Project: HMCS CARLETON

Owner: DND

2509

END OF TENDER ADDENDUM 004.

ADDN-333-001

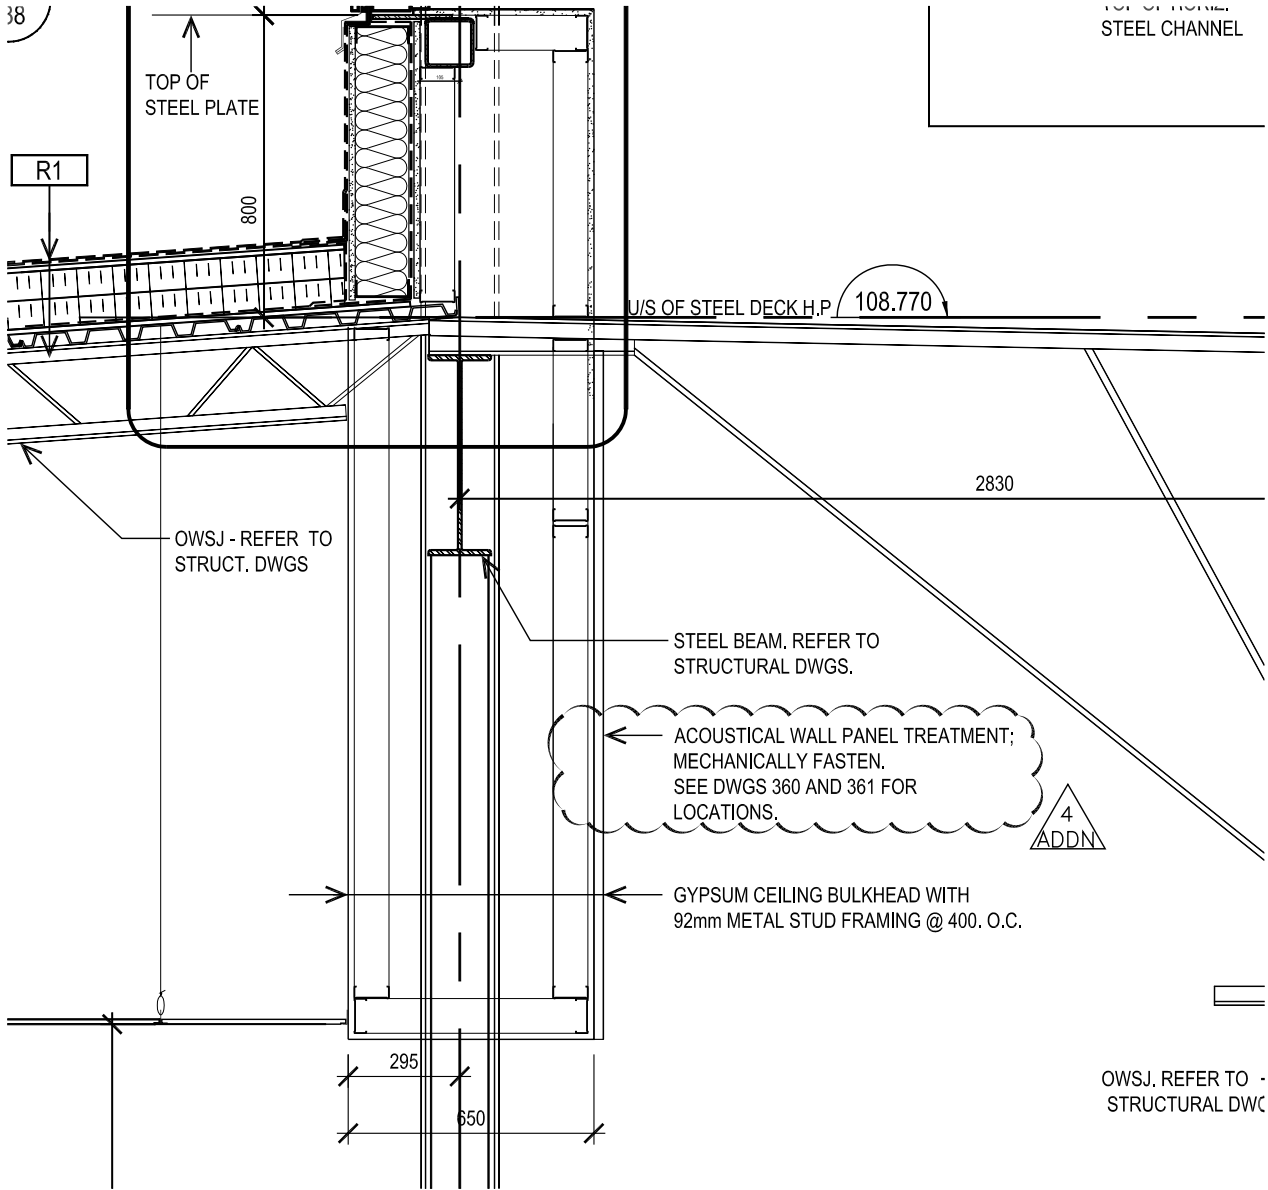
1. Revised notes for parapet details.
2. Revised note.
